# **Generic Environmental Impact Statement for License Renewal of Nuclear Plants**

## **Supplement 38**

### **Regarding Indian Point Nuclear Generating Units Nos. 2 and 3**

### **Final Report Supplemental Report and Comment Responses**

Figure H-5. Percentage of entrainment composed of RIS fish and total identified fish relative to the estimated total entrainment at IP2 and IP3 combined (data from Entergy 2007b)

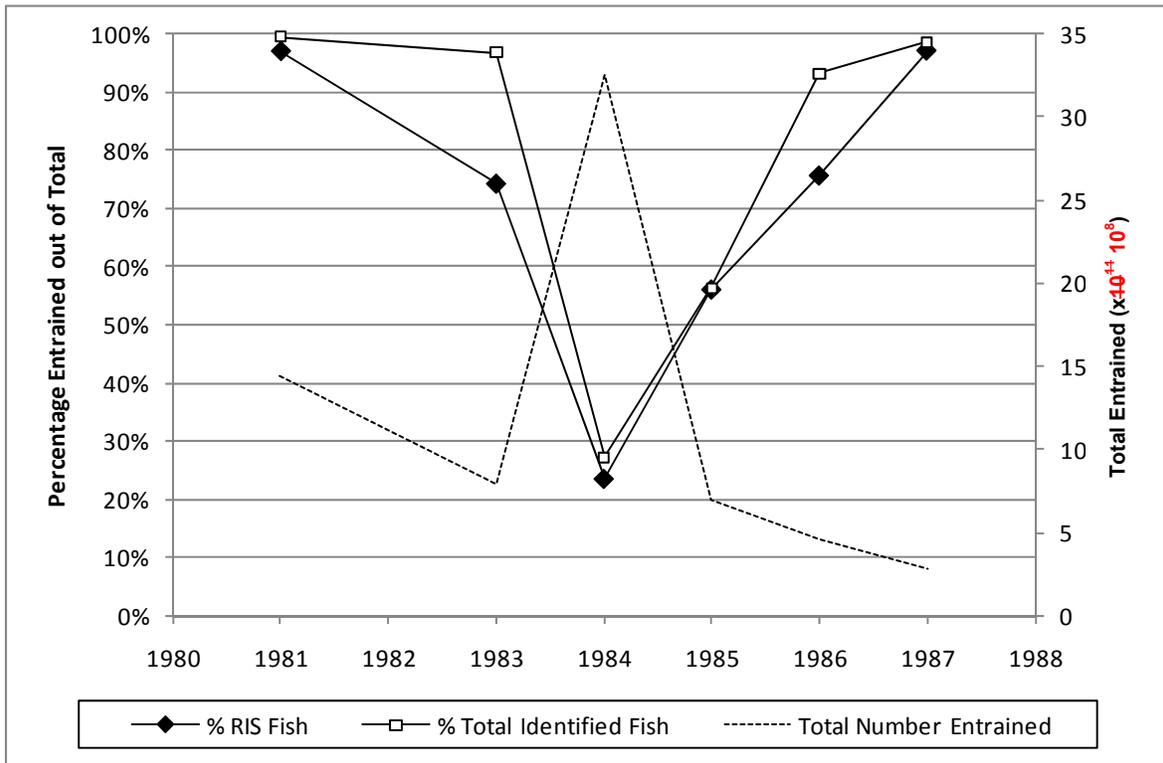
Figure H-5 on page H-23 in the FSEIS is identical to Figure 4-3 in the FSEIS and is corrected as follows:
